### Substantive: Fairway Estates Phase II PUD/Subdivision Application

Date: January 10, 2023  
To: City of Florence, Planning Department  
From: Metro Planning, Inc.  
Subject: Substantive Comments for PC 21 39 SUB 03 & PC 21 40 PUD 02

Subdivision Name: Fairway Estates Phase 2  
Map/Lot: 18-12-15-00, TL 1500  
Site Address: Florence Oregon 97439

Map 1- Open Space and Parkway Areas, please see attached plan linked below.

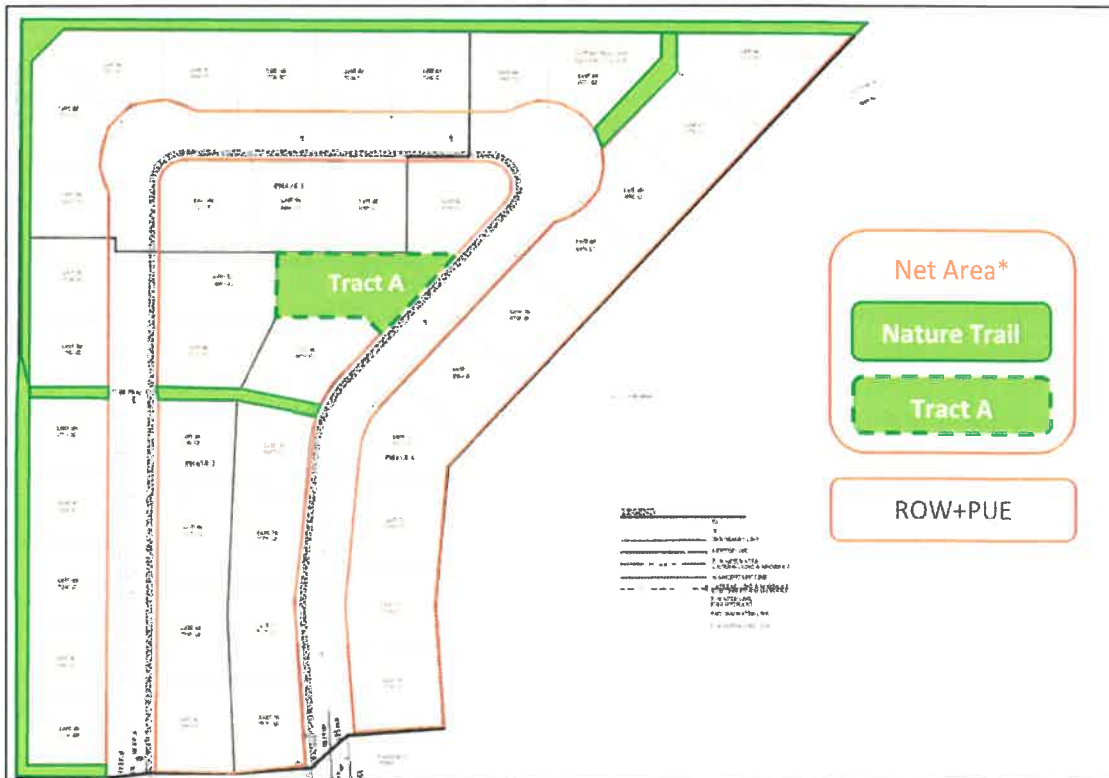
E.	Open Space: A minimum of 20% of the net development area shall be open space and must be platted for that purpose. (Easements are not acceptable). At least 25% of the 20% shall include an area designated and intended for recreation use and enjoyment. The required recreation area may be provided as: <ul style="list-style-type: none"><li>• Public dedication for use by public in general, and/or</li><li>• Property owned by the Home Owners Association (or other legal entity) for use by residents of the development.</li></ul>
----	-----------------------------------------------------------------------------------------------------------------------------------------------------------------------------------------------------------------------------------------------------------------------------------------------------------------------------------------------------------------------------------------------------------------------------------------------------------------------------------------------------------------------------------------------

5. A portion not to exceed 50% of open space and recreation area requirements may be met with a fee-in-lieu if the proposed PUD is within one quarter (1/4) mile of underdeveloped parkland as measured on public rights-of-way with reasonable pedestrian and bicycle connections to the parkland. The fee for open space shall be calculated by multiplying the sq. ft. of open space area being met with fee-in-lieu multiplied by the average square foot value of abutting real property as shown on the current Lane County assessment roll, less a percentage for easement retained for public use. The fee for recreation area will include the open space methodology and additional fee for improvements planned for the underdeveloped parkland as identified in the Parks and Recreation Master Plan or in a City Council approved community park plan for that park.

Response: Please see table below for Open Space (and Parkland) area breakdown.

Table above lists proposed Open Space by percent of Net Area. Net Area is the overall site area (extending to the plat boundary) minus the sum of public utility easement (PUE) and right-of-way (ROW) areas. Please see illustration below.

Response: Applicant requests that less than 50% of open space and recreation area (34,202 SF) requirements be met with a fee-in-lieu, according to FCC 10.23.5.E.5. Proposed PUD is within one quarter (1/4) mile of underdeveloped parkland, to the north of the site, and connects to the Parkland via the nature trail.

Map 2 - Nature Trail Connection, Revised Utility Map<sup>4</sup>

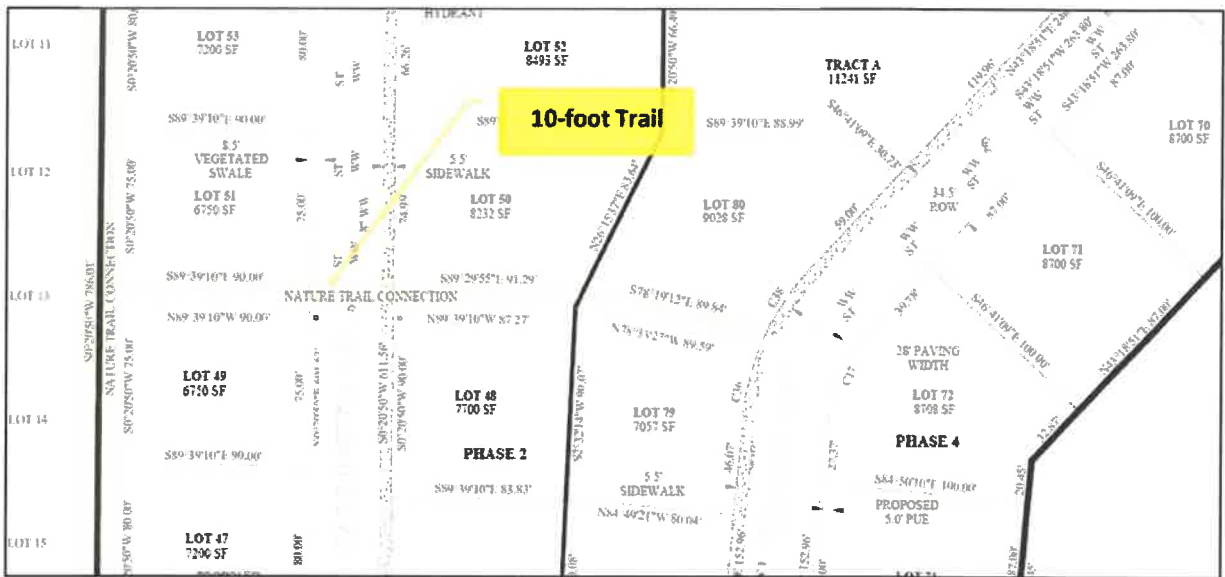
- 2. SUB: Findings for FCC 11-5 (e.g. 10-36: block length and perimeters, intersection angles, etc.) According to 10-36-2-10. A: Block Length and Block Perimeter: Residential Districts: Minimum of 100-foot block length and maximum 600-foot length; maximum 1,400-foot block perimeter ...**

In support of the purpose of FCC 10-36-2-10, applicant proposes a nature trail near the middle of a block in-lieu-of a street connection and also seeks Planning Commission consideration with a request for exception/modification to block length requirement. (Please see written statements below under FCC 11-7 that address exception/modification criteria.)

Please see attached Plans for more detail<sup>3</sup>. Please see illustrations of Nature Trail Connection on Revised Utility Map below.

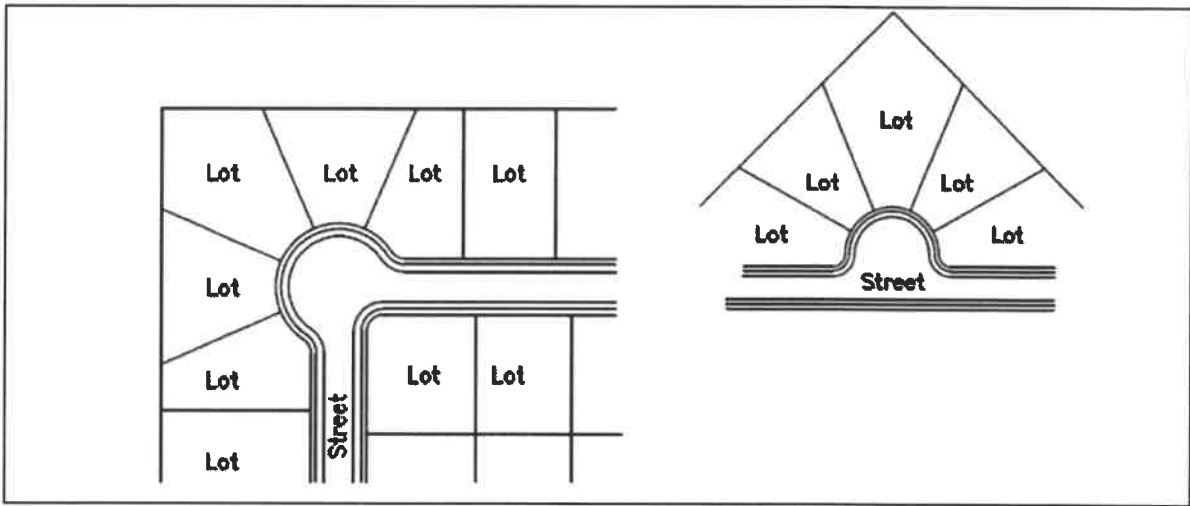
**10-36-2-14: Intersection Angles: Streets shall be laid out so as to intersect at an angle as near to a right angle as practicable, except where topography requires a lesser angle. In no case shall the centerline angle be less than 80°; elbow or knuckle corners are not allowed ...**

Response: Applicant provides a valid petition that states the provision sought to be modified and facts showing that code provisions cause unique and unnecessary hardship, that proposed modifications of code provision would not be contrary to code purpose and that proposed modifications enhance emergency access.

1) Allow knuckle corners and modified intersection angles, 2) allow exception to 600-foot block maximum length with modification of approximately 145 feet, and 3) allow exception to maximum 1,400-foot block perimeter with modification of approximately 680 feet.
